From: Webster, Gary [REDACTED]
Sent: 15 May 2020 15:22
To: Jones, Julian D; Maria Tomalova
Cc: Gateley, Jon
Subject: RE: BN/18/20/PL, Former Brooks Nursery
Attachments: 4482-506(D) S104 Layout Phase 2.pdf; 4482-510A Foul Outfall Rising Main Details.pdf; 4482.502E Phase 1 Section 104 layout.pdf

From: Jones, Julian D [REDACTED]
Sent: 15 May 2020 14:59
To: Maria Tomalova <Maria.Tomalova@arun.gov.uk>
Cc: Webster, Gary [REDACTED] Gateley, Jon [REDACTED]
Subject: BN/18/20/PL, Former Brooks Nursery

Project Brooks Nursery Barnham

SECTIONAL PLAN
TYPE 2
MAX DEPTH TO PIPE SOFFIT 3.0m

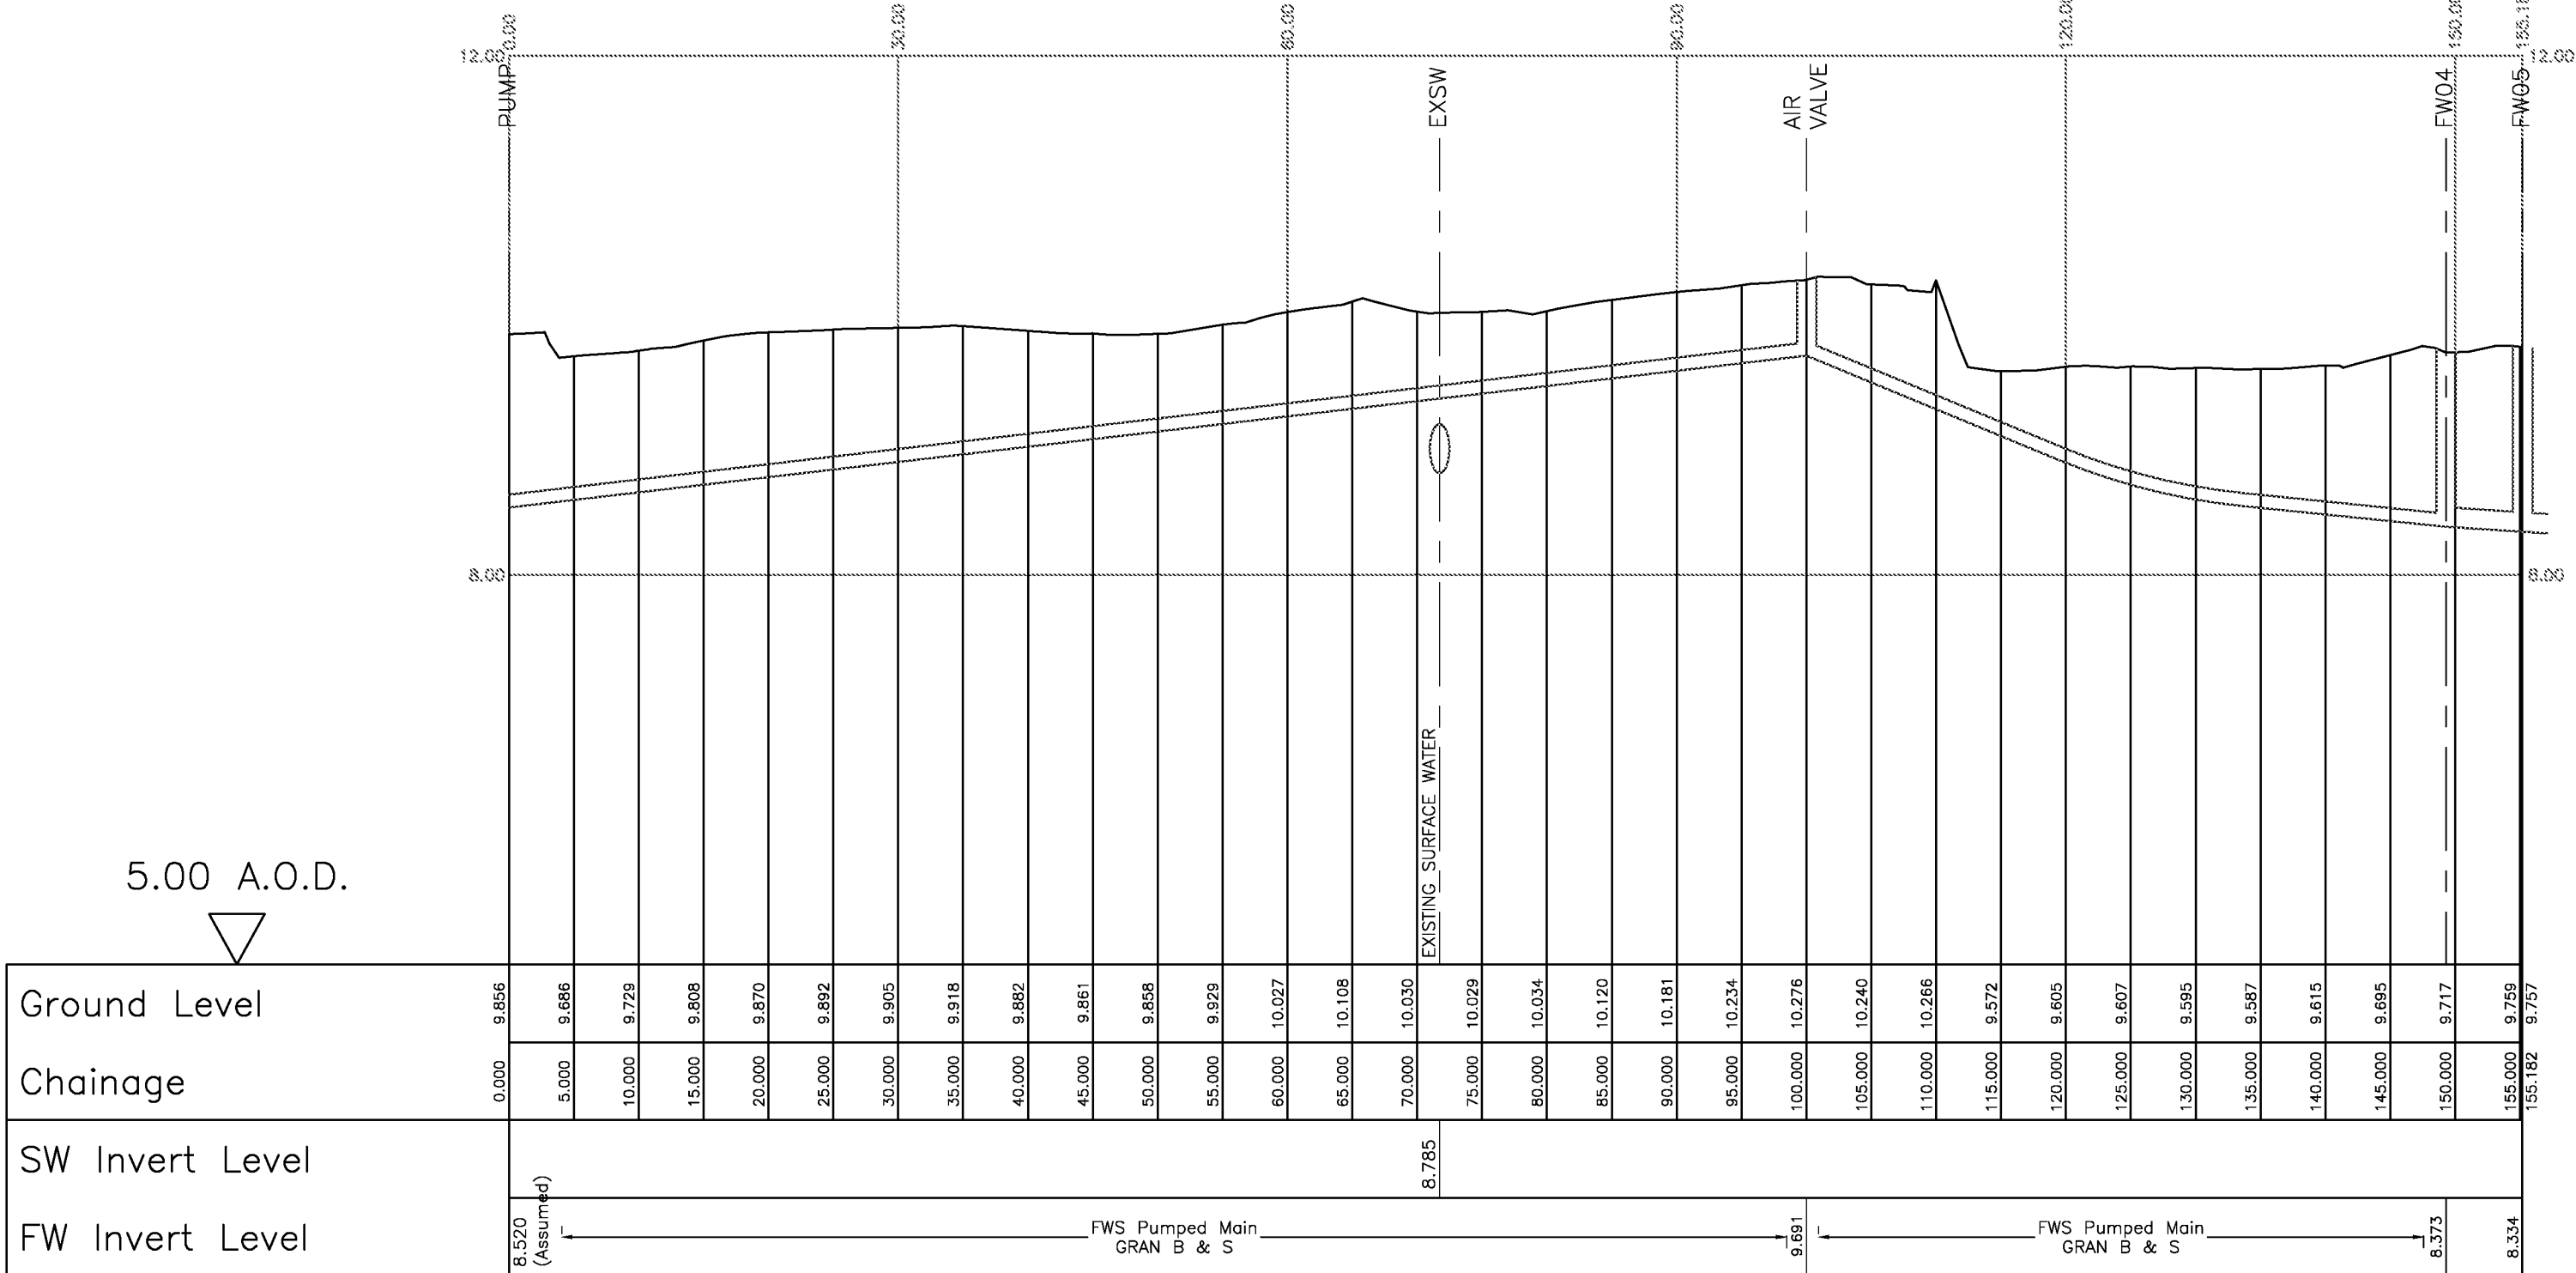
- a) The open channel/ditch in which the sewage treatment plant discharges into at present, before it connects into the suds pond, is proposed to be infilled.
The applicant will need to provide written confirmation with supporting calculations to prove that the storage for surface water within the suds system is not compromised as a result.
- b) Where the proposed rising crosses the incoming surface water outfall to the pond and the known land drain running parallel to the eastern boundary of the development, the applicant should provide a longitudinal section to prove no impact on these pipelines.

Finally, the long section requested was already shown on drawing no, 4482.510A , which I attach for reference along with the other engineers drawings which were agreed at the meeting
